APPEAL SUMMARY

| Appeal ID: 33407 | Project Address: 3950 N Williams |
| Building/Business Name: Kiley40 | Fire Sprinklers: Yes - Whole building |
| Appeal Involves: Erection of a new structure, Reconsideration of appeal | LUR or Permit Application No.: 24-029720-CO |

1ST FLOOR PLAN

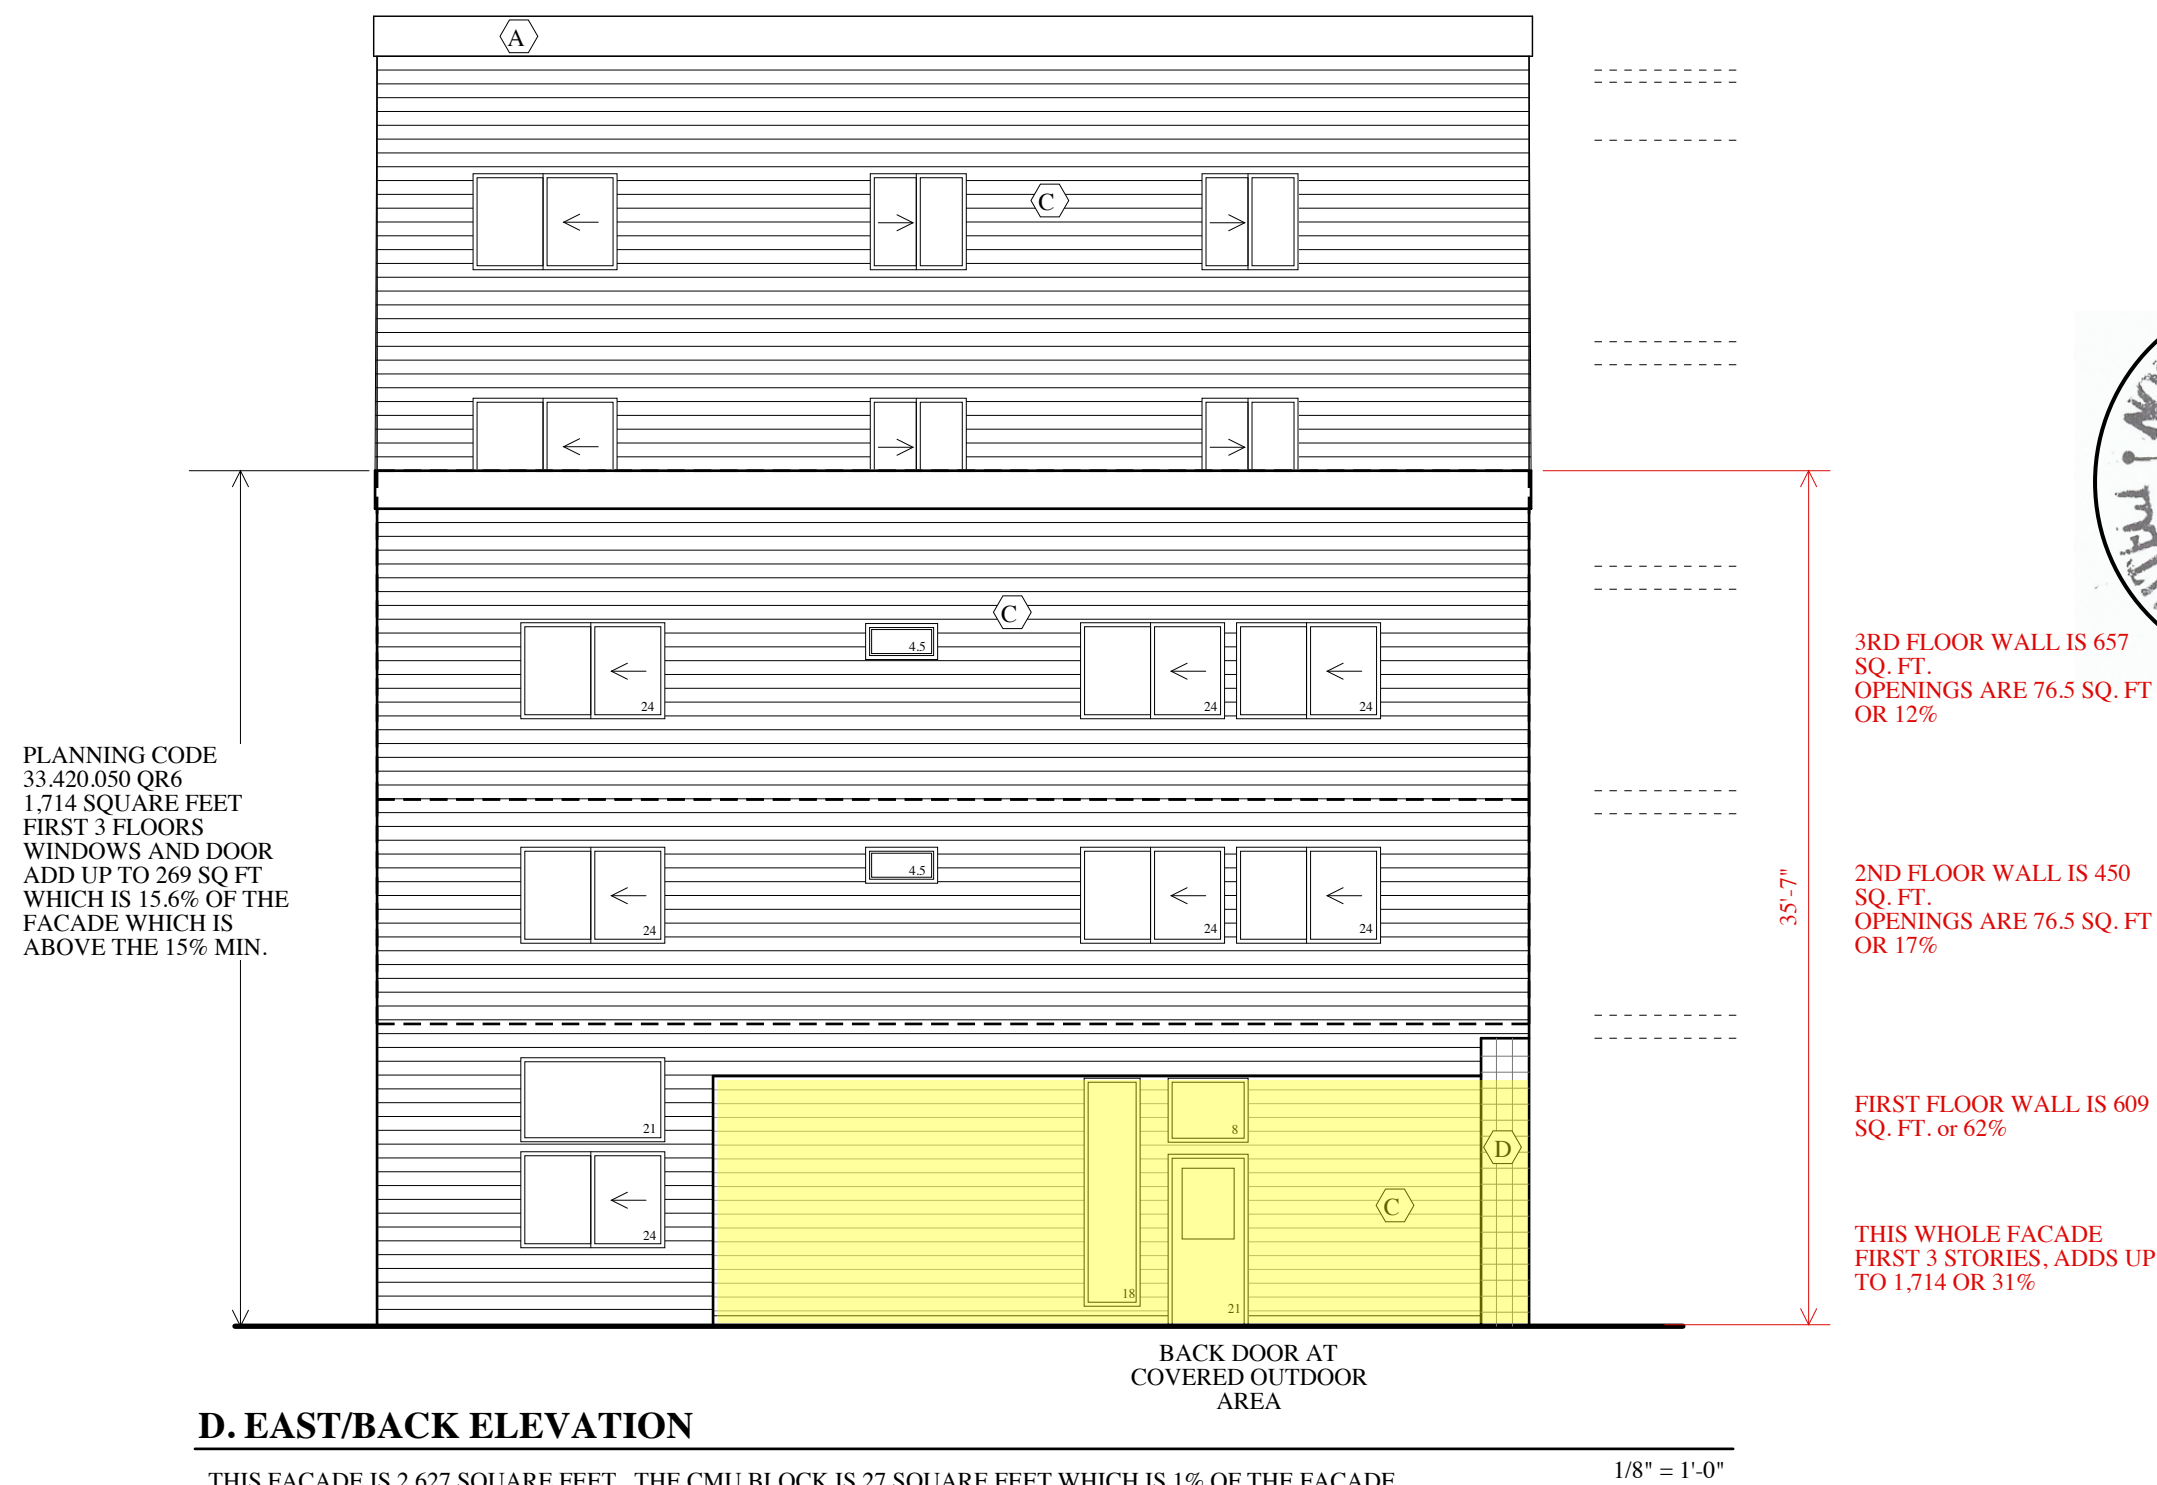
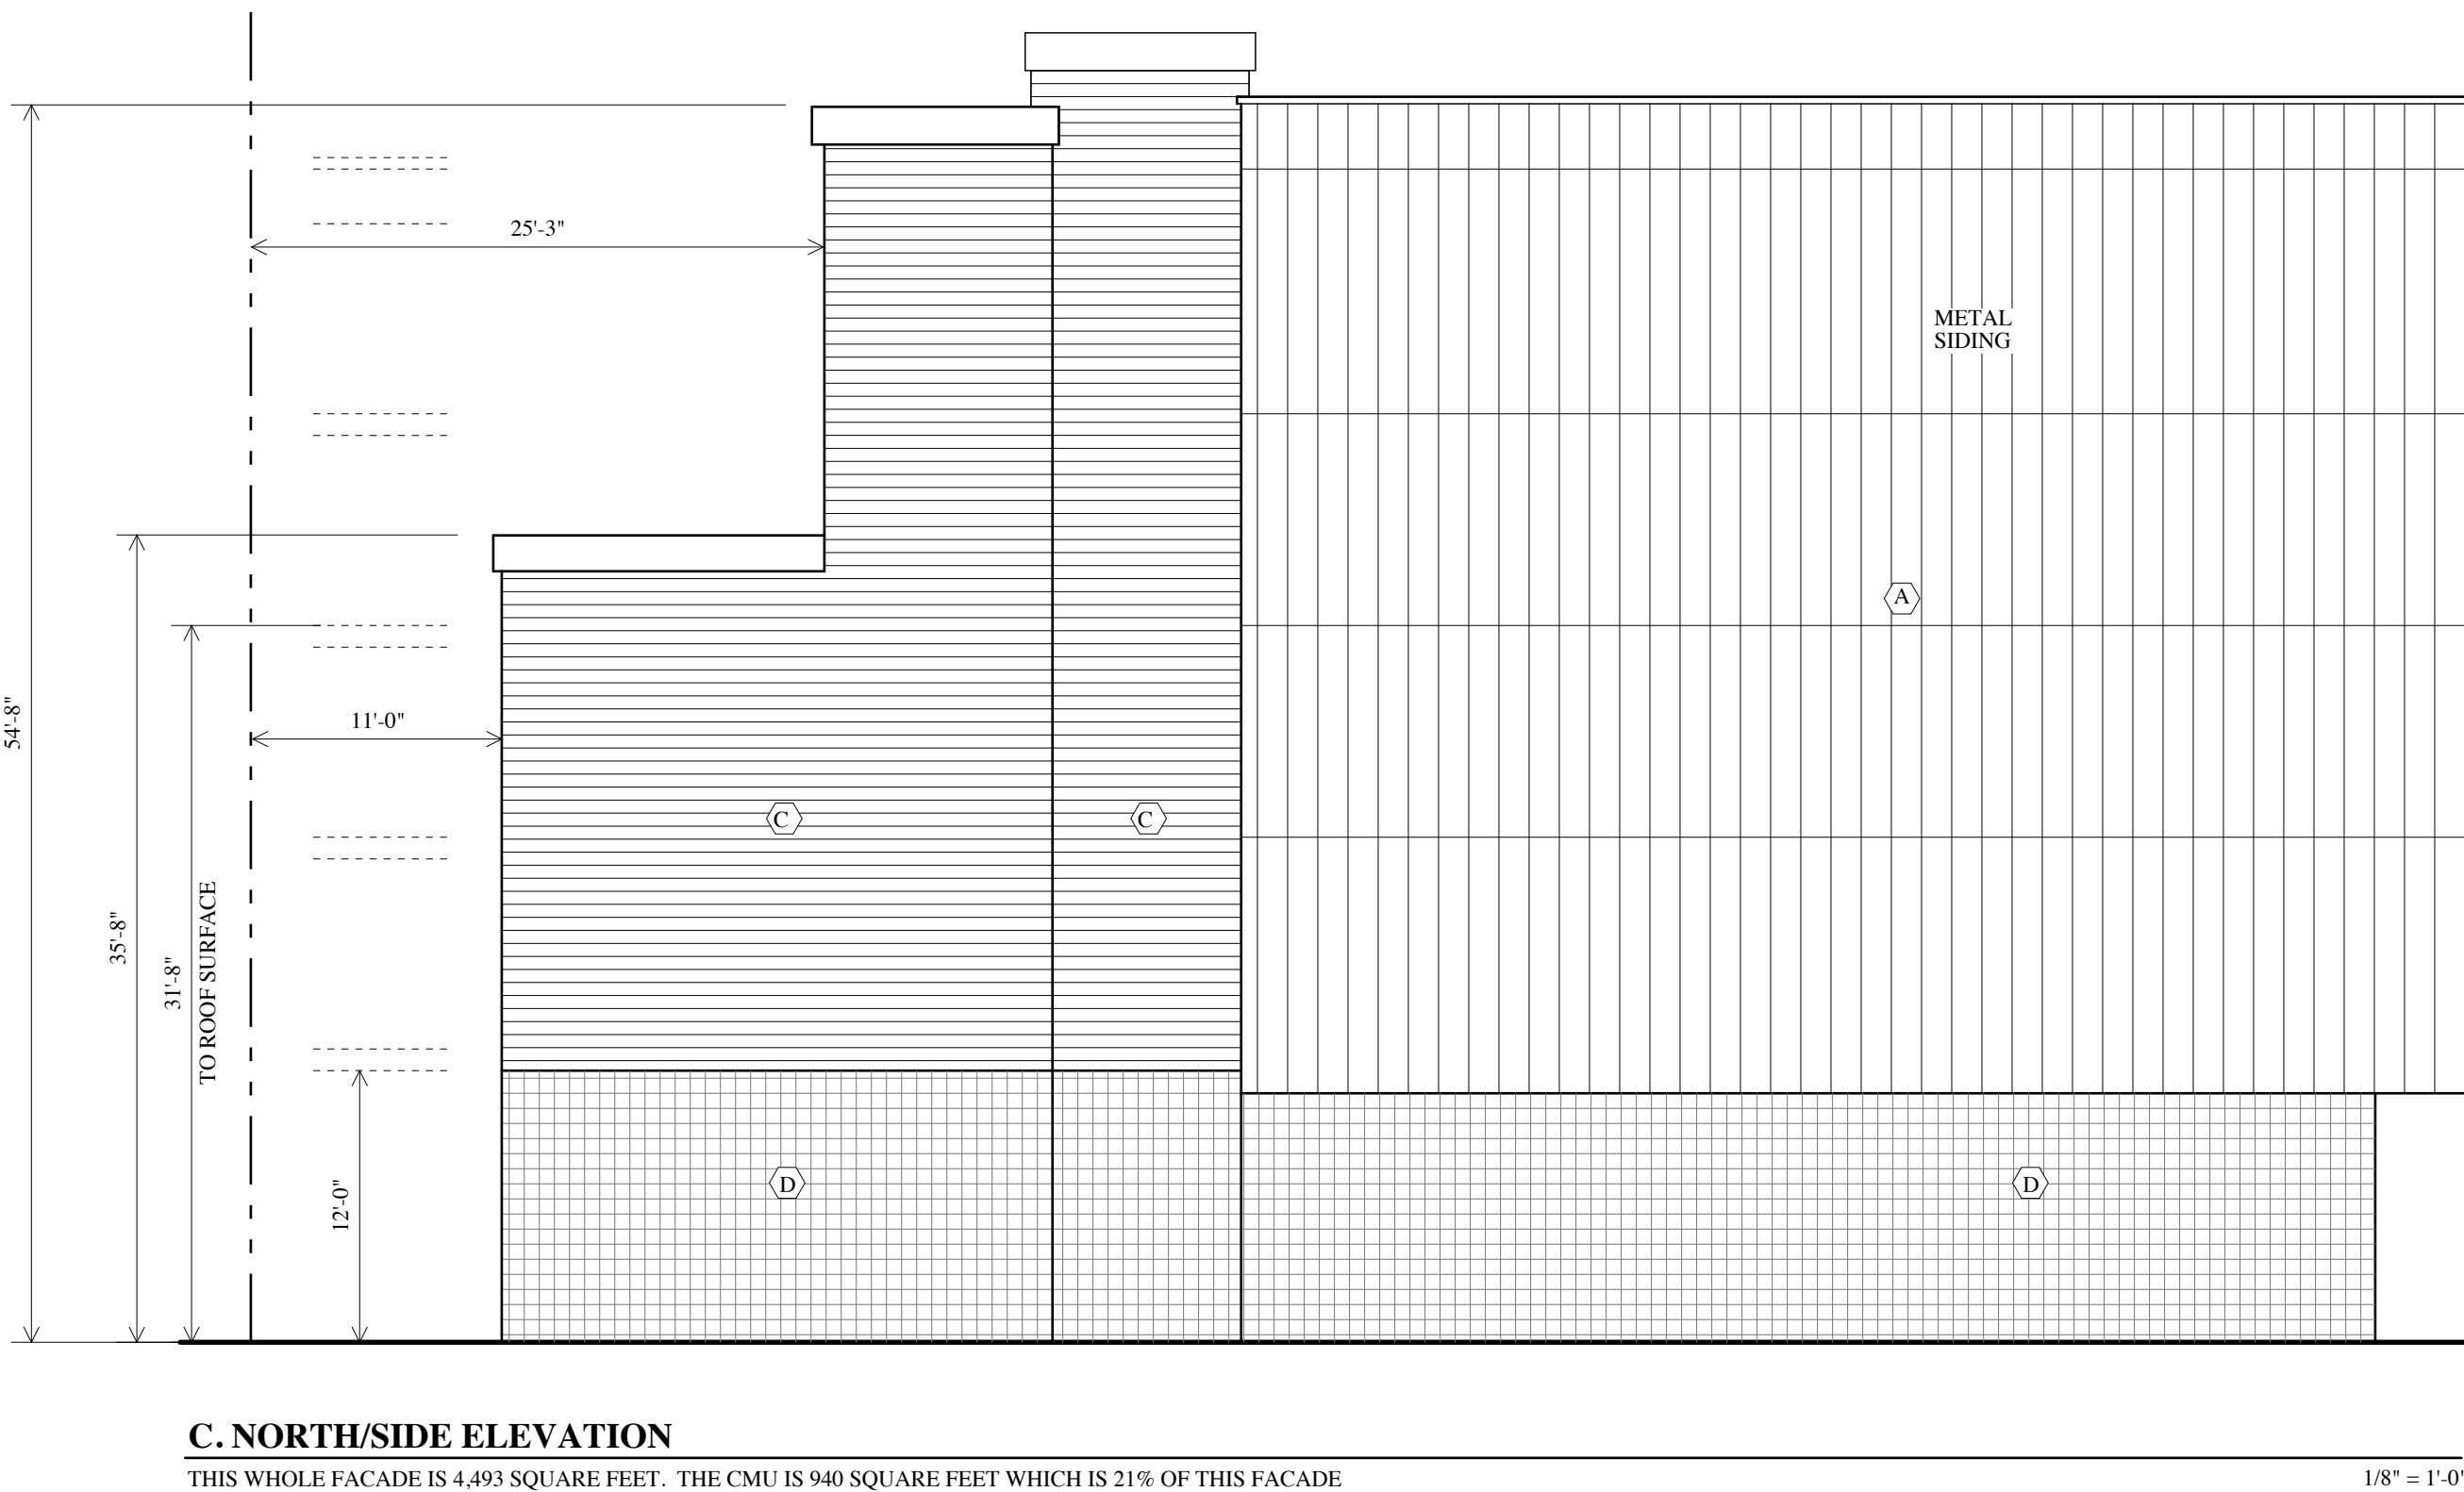
The proposal is to add an illuminated exit sign to be visible from the exit discharge, the door from the stairwell to the lobby.

Reconsideration: To still add the illuminated exit sign to be visible from the exit stair enclosure but to also consider the area between the exit stair enclosure and the exterior exit door an exit passageway by making the walls and ceiling at the corridor 2-hour fire rated construction. The doors in the exit passageway will be 90-minute rated.

| Proposed Design | The proposal is to add an illuminated exit sign to be visible from the exit discharge, the door from the stairwell to the lobby. See location noted in red on the first floor plan. |

- "1) Increase of allowable wall opening percentage from 45% to 62% on the first floor of the east side: Granted provided the fire rating of the floor-ceiling assembly above the patio is increased to a 2-hour fire-resistance rating.**
- 2) Alternate method for determining fire resistance rating of 2-hour shaft wall assembly: Granted structural engineering calculations for connecting and supporting the gypsum board layers in this incline orientation are provided and approved during plan review.**
- 3) Continuation of interior exit stair to exit discharge with exit passageway: Exit discharge from an exit stair through an exit passageway meets the 1023.3 Exception and does not require a building code appeal. However, the current configuration does not meet the requirements for exit passageways (for example: 1024.5 Openings). "**

PRINT DATE: 4 24 2024
SHEET
6.0
OF 16
ELEVATIONS

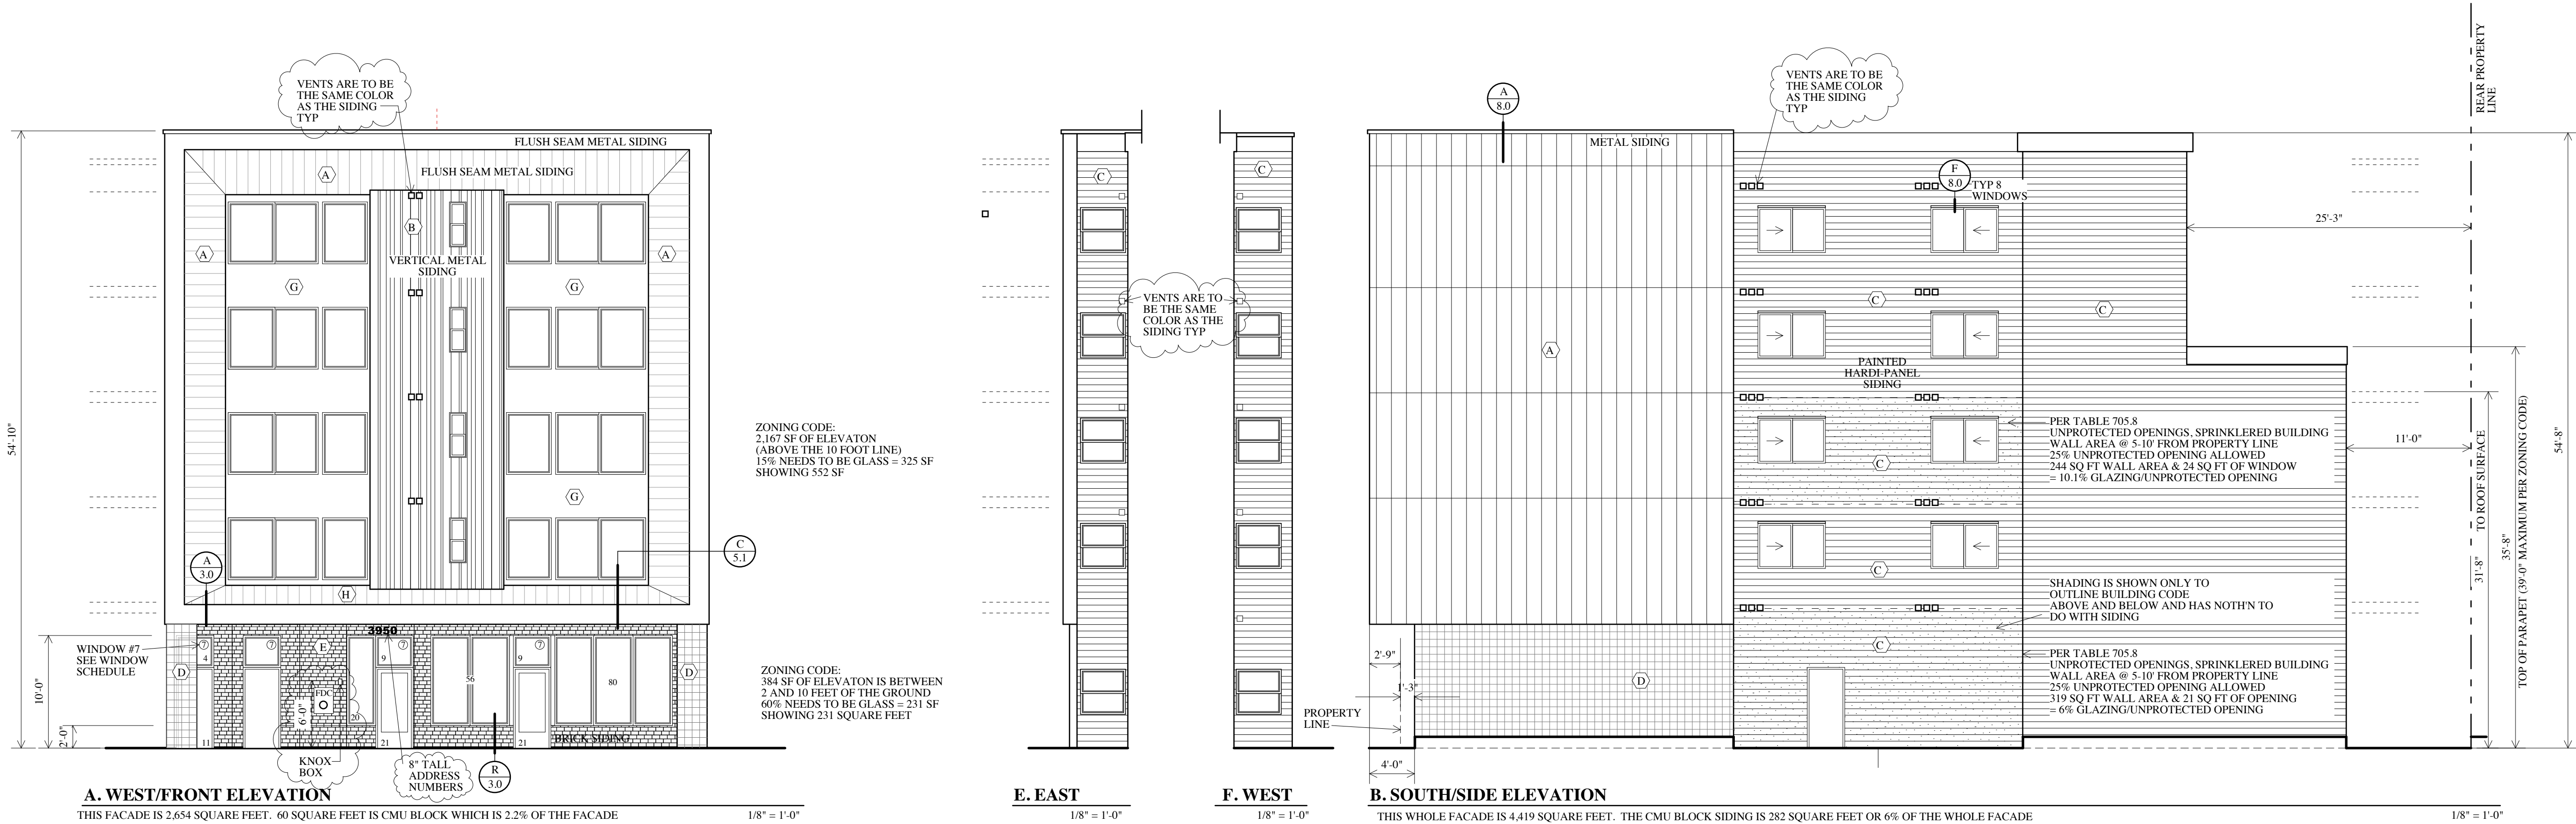
Original appeal: The proposal is to consider the wall facing the property line on the first floor, which is the wall with a door in it accessing the outdoor space, as the wall with the unprotected openings and not consider the open space at the edge of the wall above it as a wall.

The exterior façade is 1,714 square feet and the allowable unprotected openings is 45% of that number which is 770 square feet. The amount of unprotected openings in this façade is 531 square feet which is 31% of the façade. The proposal is to consider the whole façade having fewer than 45% unprotected openings instead of each story. Also on the first floor the wall separating the interior from the exterior space is not being considered the exterior wall to be regulated by fire code, then it is not required to be 2-hour fire rated like the rest of the exterior walls. We are proposing to continue that 2-hour fire rating on this wall.

Consider that first floor does have a 333 square foot unprotected opening which is not a window or a door but an opening to an exterior patio. The walls between that patio and the interior of the building are 2-hour fire rated. That is a fire wall that is an additional layer of protection to the codes listed in table 705.8. Also this patio has a 1-hour fire rated ceiling. All of this provides additional protection that is not required inside an unprotected opening and this is the additional protection that makes me feel this design is meeting the code.
